1984 - 1990 Corvette: Service Bulletin: Power Seat Inoperative and/or Blows Fuses

Subject: POWER SEAT INOP/BLOWS FUSES REPAIR/REPLACE HARNESS

Model and Year: 1984-90 CORVETTE

Bulletin Number: 90-412-10 - (03/18/1991)

Figure 1

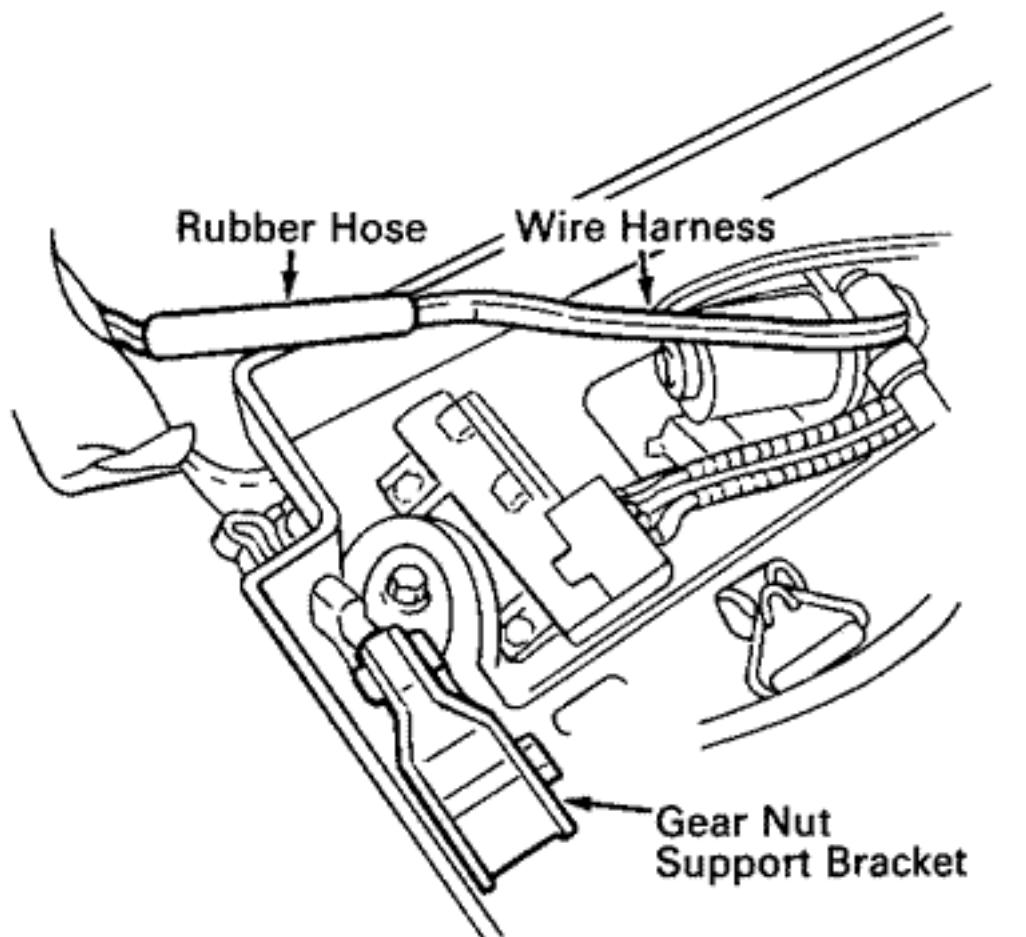
Power Seat (AQ9) inoperative and/or blows fuse.

Seat Control Switch Wire Harness may be shorted at gearnut support bracket. (See Illustration) With seat cushion installed, harness contacts gearnut support bracket and may become shorted with weight of driver/passenger.

Repair and/or replace harness as required. Using a section of rubber hose (gas line) about (4) inches long (split), cover harness as illustrated taping both ends.
